GGG–C–748b
AMENDMENT—3
April 18, 1963

FEDERAL SPECIFICATION

CUTTER, CIRCLE (ADJUSTABLE); FOR GASKETS AND WASHERS

FIGURE 7.—Type IV, style A, drill pivoting, bit shank.

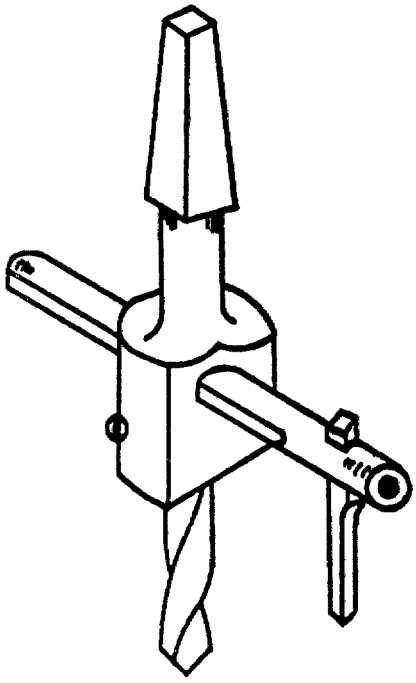
Page 9, figure 7: Delete and substitute:
